# WATER QUALITY MEMORANDUM

Utah Coal Regulatory Program

TO: Internal File  
THRU: Jim Smith, Permit Supervisor *JS 13 Dec 2010*  
FROM: Steve Christensen, Environmental Scientist *SKC*  
RE: 2010 Second Quarter Water Monitoring, West Ridge Resources, West Ridge Mine, Task ID #3576

### Spring SP-101

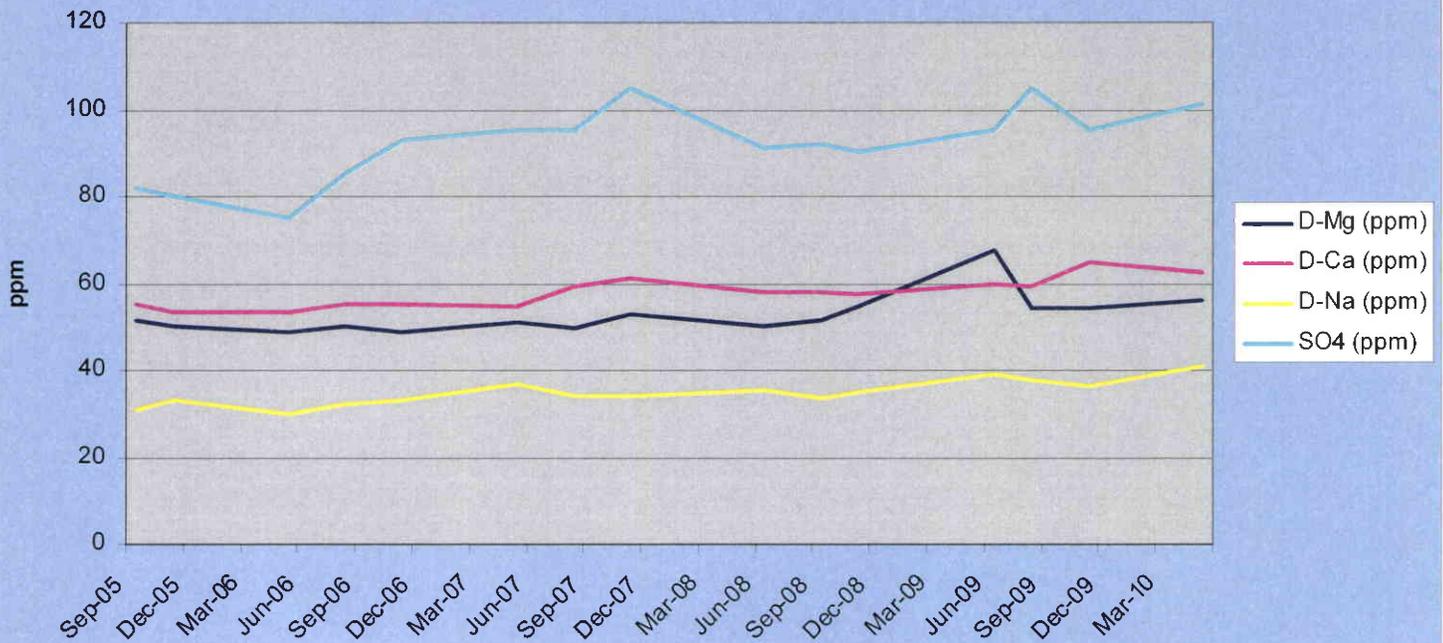
Spring monitoring site SP-101 reported elevated levels of dissolved sodium (D-Na). Last quarter, the site was inaccessible. An elevated dissolved calcium (D-Ca) value was reported the previous quarter (WQ09-4).

### Spring SP-12

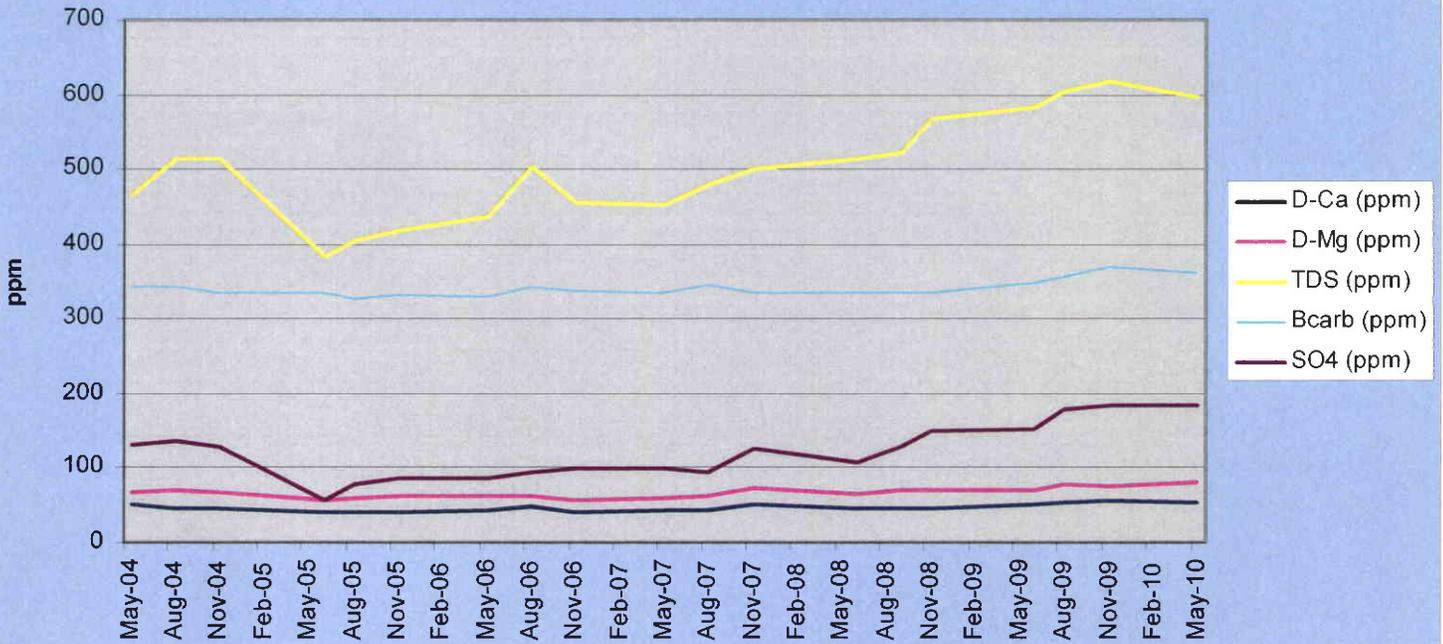
Spring monitoring site SP-12 reported elevated concentrations/values for conductivity (Cond.), D-Ca, D-Mg, D-Na, sulfate (SO<sub>4</sub>), T-Hardns, total dissolved solids (TDS), Bcrb, T-Cats and total anions (T-Anis). The previous quarter, the site was inaccessible. However, elevated concentrations of the aforementioned parameters were reported the 3<sup>rd</sup> and 4<sup>th</sup> quarter of 2009 (WQ09-3 and WQ09-4). Continued monitoring of these parameters will be conducted in order to evaluate a potential cause for the elevated concentrations of TDS and its primary components.

### ST-5: TSS vs. Time

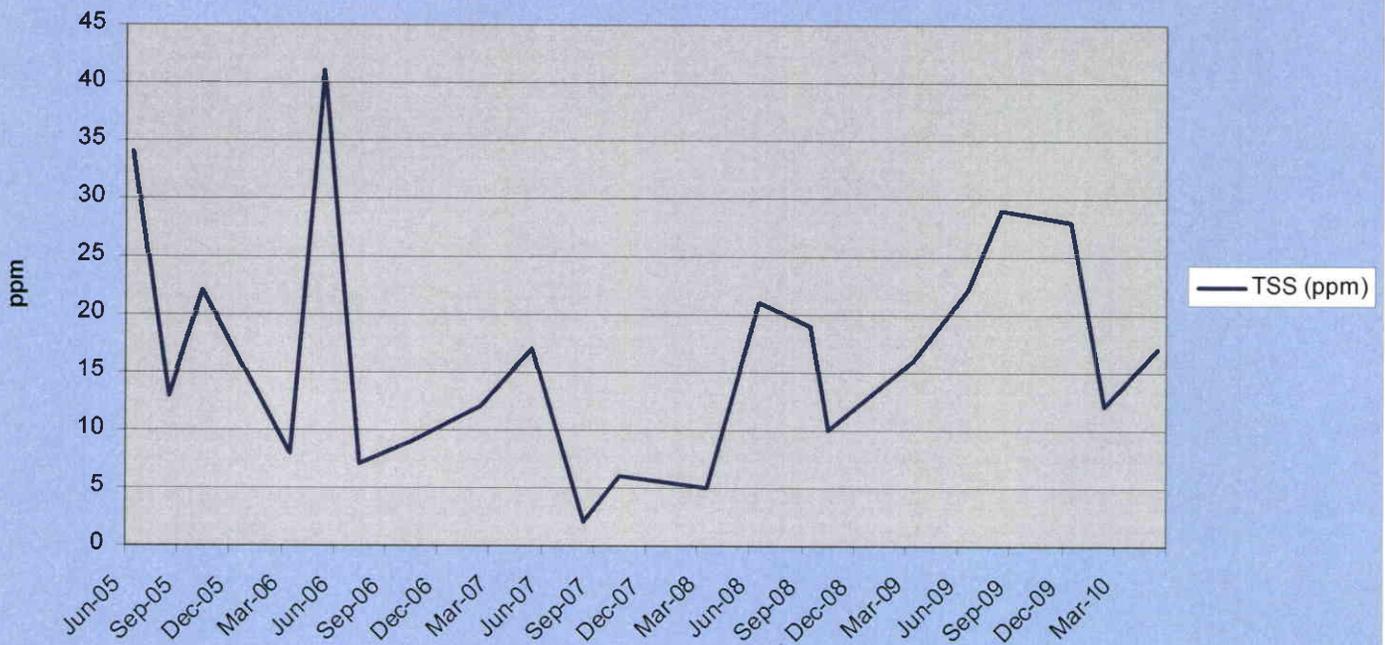
The reported TSS value for site ST-5 increased from 12 ppm (WQ10-1) to 17 ppm this quarter. However, the concentration is significantly lower than what was reported the last three quarters of 2009 (22 ppm, 29 ppm and 28 ppm respectively).

### ST-5: T-Fe vs. Time

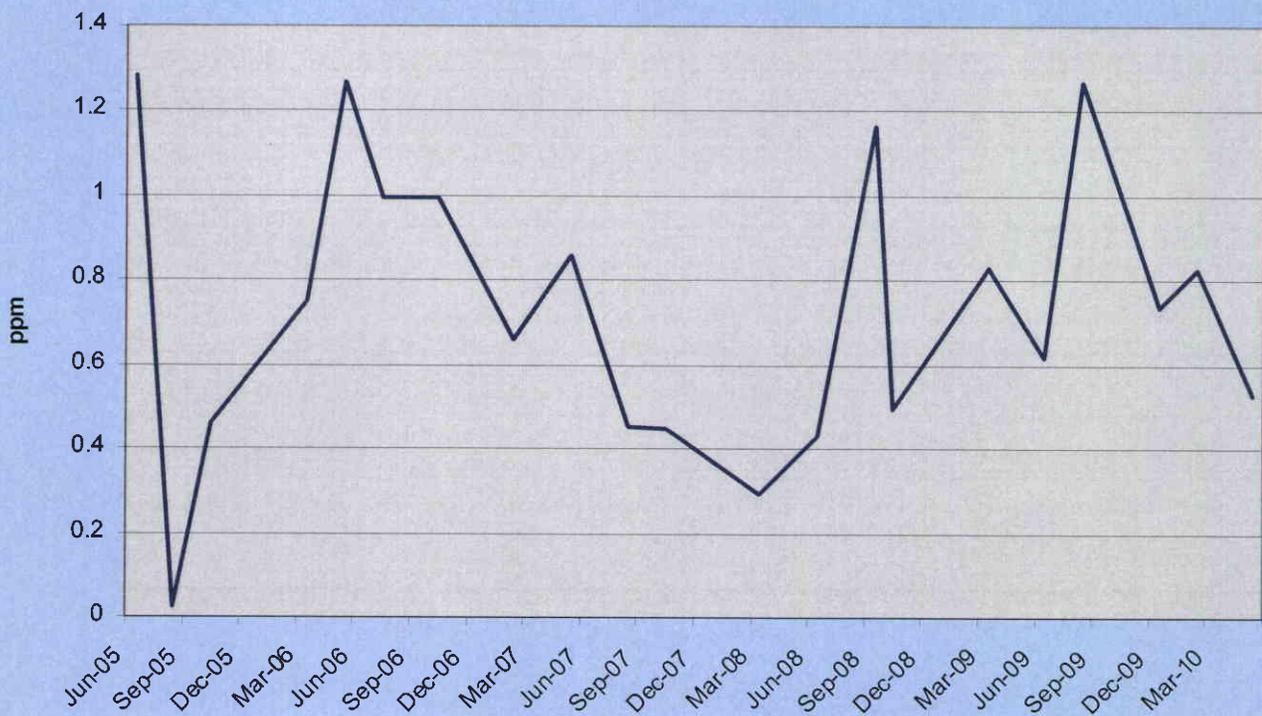
The reported T-Fe value for ST-5 went down from 0.824 ppm the previous quarter to 0.53 ppm this quarter. The T-Fe values at this monitoring site have been steadily decreasing since the 3<sup>rd</sup> quarter of 2009.

### ST-6: TSS vs. Time

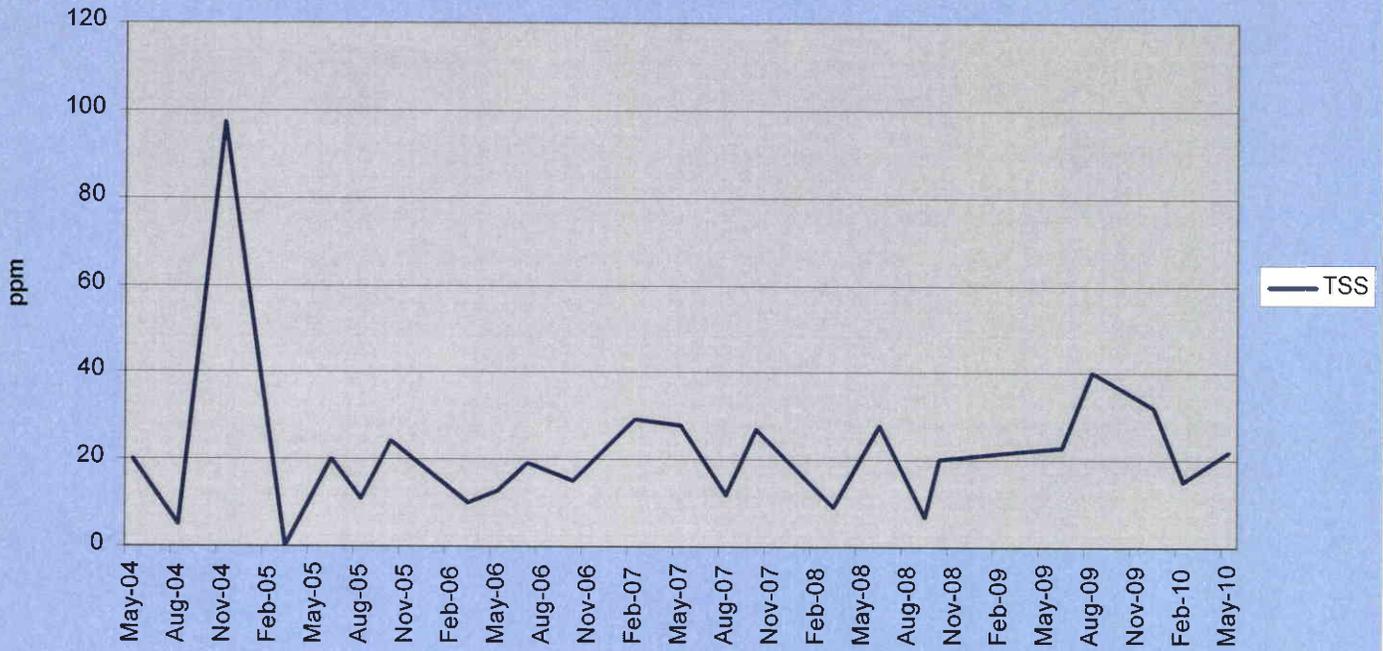
The reported TSS concentration increased from the previous quarter to 22 ppm from 15 ppm. Additionally, the T-Fe concentration increased significantly from 0.724 ppm the previous quarter to 1.267 ppm this quarter. The UPDES compliance limit at Outfall 002 (mine-water discharge) for T-Fe is 1.3 ppm. The 1.267 ppm concentration is a concern in that such a high concentration was obtained approximately 1 mile from UPDES discharge point 002. Continued monitoring will be conducted.

### UPDES Outfall D002: Total Iron (T-Fe) vs. Time

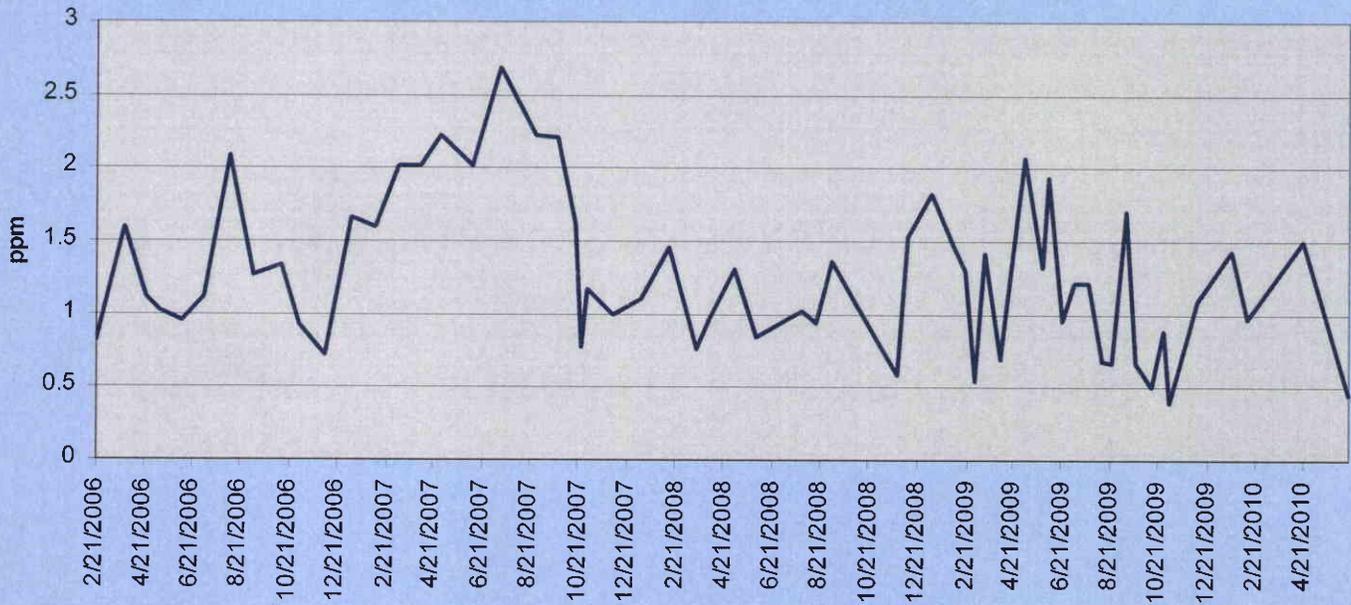
UPDES Outfall 002 was sampled two times this quarter. The reported concentrations for TSS and TDS were well below the compliance limits as established by the UPDES discharge permit. However; the April 21<sup>st</sup> sampling event reported an elevated T-Fe concentration of 1.504 ppm. The Division of Water Quality is aware of the elevated T-Fe value and continued monitoring is being conducted.
